CROSSROADS CHRISTIAN CHURCH

**Re: Crossroads Christian Church / Fayette County  
Construction Storm Water Permit 4GC03243\*AG**

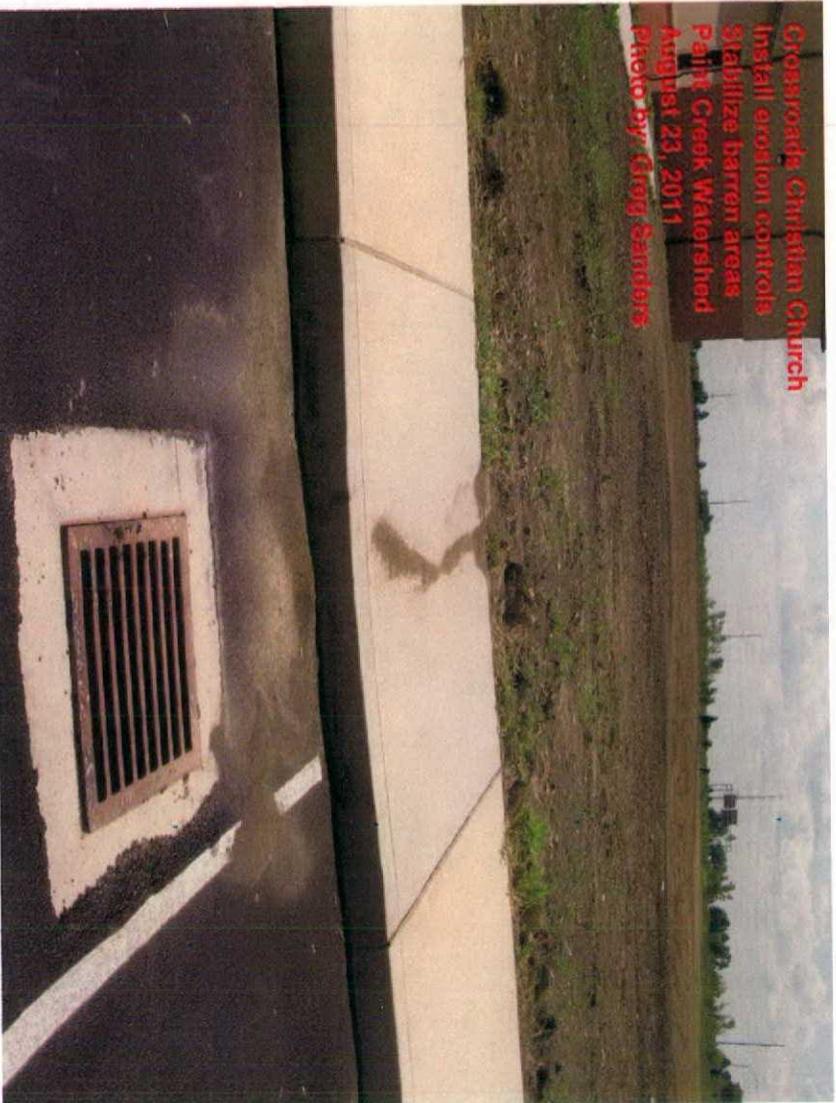
Crossroads Christian Church  
Stabilize barren areas  
Paint Creek Watershed  
August 23, 2011  
Photo by: Greg Sanders

Crossroads Christian Church  
Install erosion controls  
Stabilize barren areas  
Paint Creek Watershed  
August 23, 2011  
Photo by: Greg Sanders
